GARAGE / BEAM & SUPPORT COORDINATION DRAFT

Current support positions drive draft member axes. Geometry only; bearing details unresolved.
OB1 is listed separately as outbuilding context. E-M is option B only. Roof/loft outlines are plan limits.

T-N / PARAMETRIC TRUSS STUDY

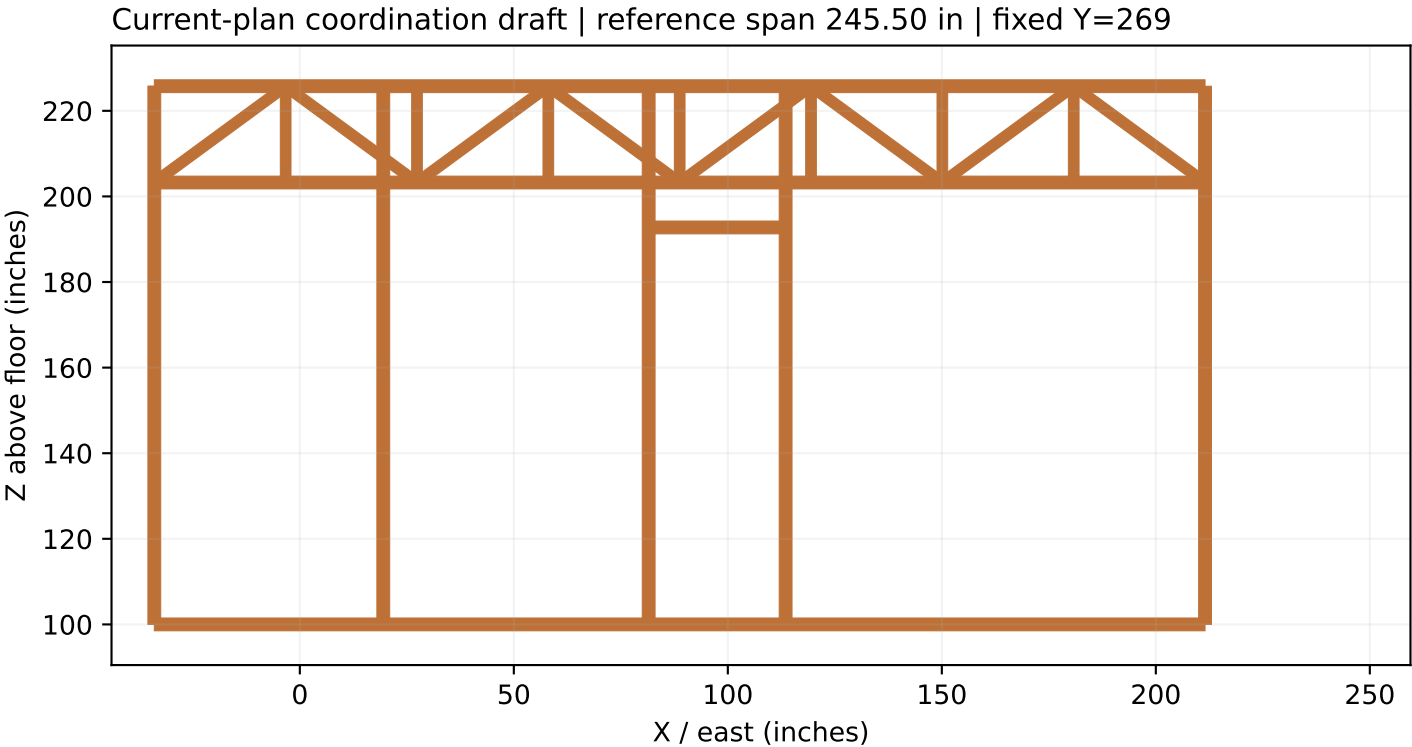
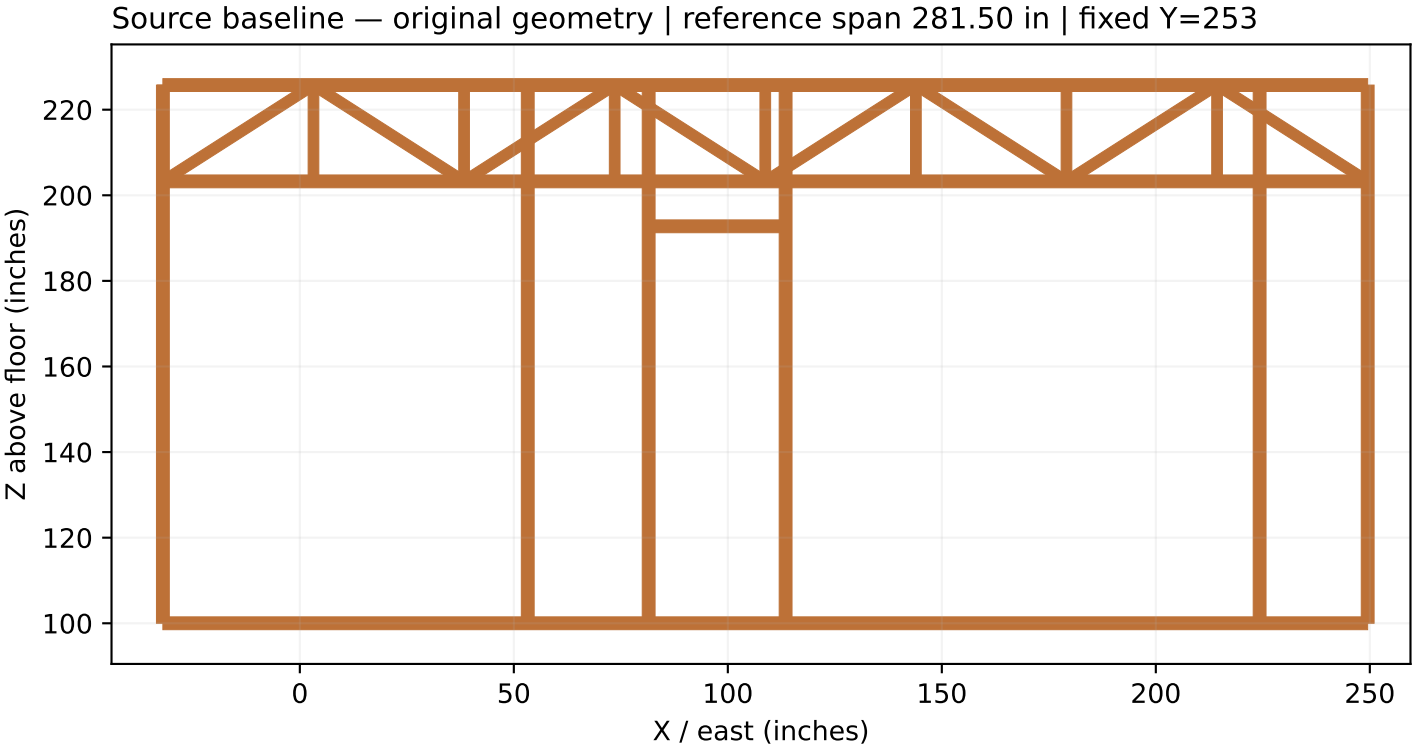
7. T-N loft-door jamb axes X81.5/113.5 give 29 inches between 3-inch faces; source 32 inches is axis spacing.
8. T-W source door header gives 81.5 inches from loft floor to underside; source opening height needs coordination.
